Memorandum Planning & Development Services Division

RE: **P.Z. 14-2016 18331, 18333 & 18335 Chesterfield Airport Rd. (LSL I, LLC and LSL II, LLC.)**: A request for a zoning map amendment from a “M3” Planned Industrial District to a “PC” Planned Commercial District for a 16.0 acre area of land at 18331, 18333 and 18335 Chesterfield Airport Rd., located at the northwest side of the intersection of Chesterfield Airport Rd. and Spirit of St. Louis Blvd. (17V410060, 17V410026 and 17V410037).

AMENDMENT 1:

Green Sheet

PRELIMINARY PLAN

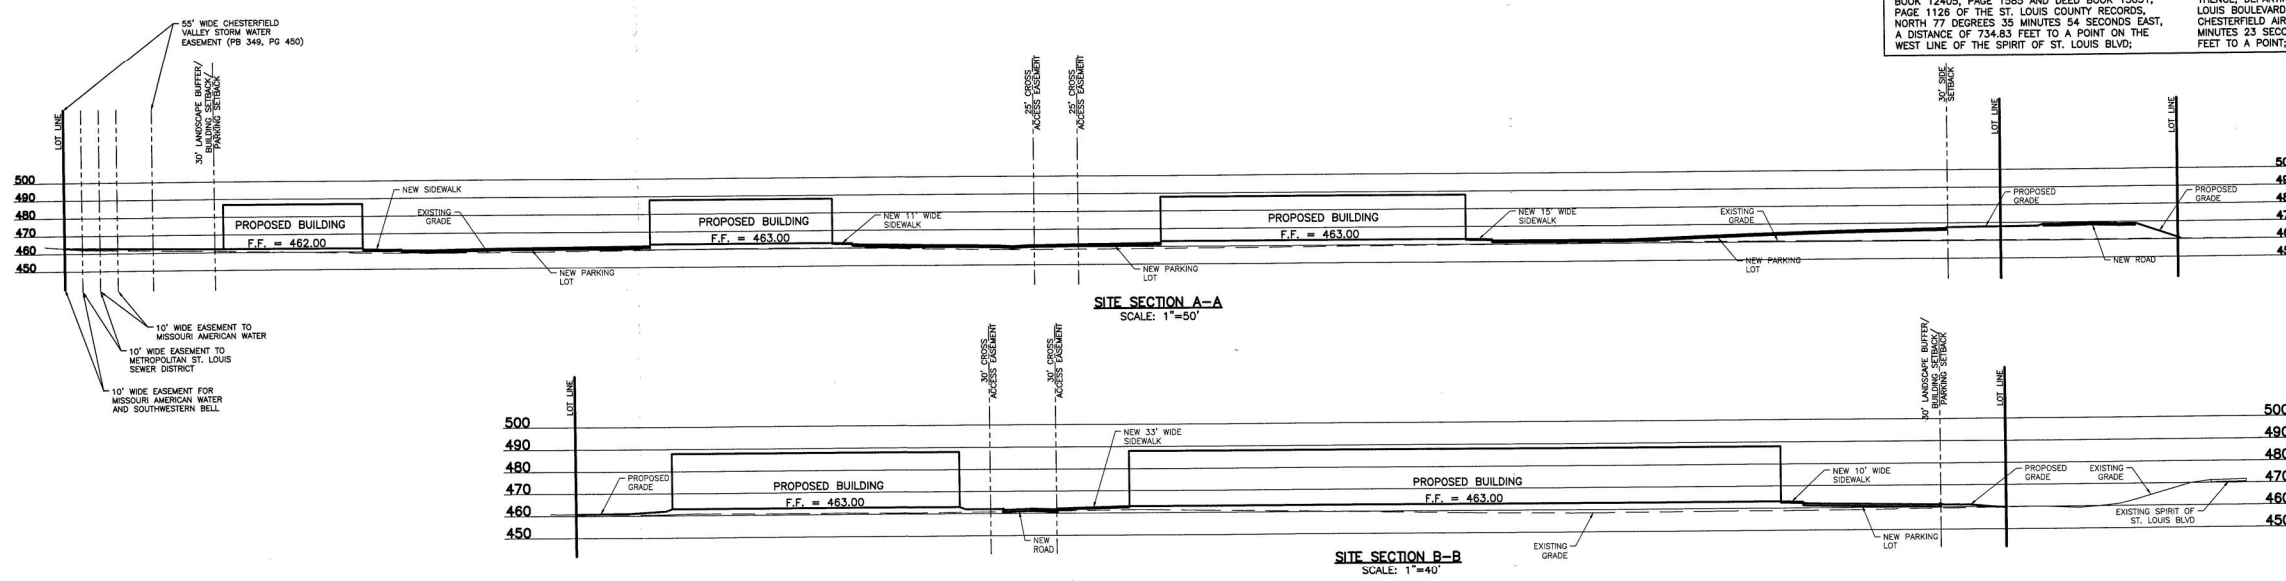
- The final alignment of the Olive Street Road extension shall be as directed by the City of Chesterfield and St. Louis County Department of Transportation. Should the final alignment differ from the Preliminary Site Plan attached hereto as Attachment "B", the developer shall dedicate the right-of-way necessary to achieve the final alignment upon request of the City of Chesterfield and/or St. Louis County Department of Transportation.

1. At such time that the Olive Street Road extension becomes a state roadway under the jurisdiction of the Missouri Department of Transportation, the northern access point to this roadway shown on the Preliminary Site Plan attached hereto as Attachment "B" shall be terminated as directed by the City of Chesterfield.
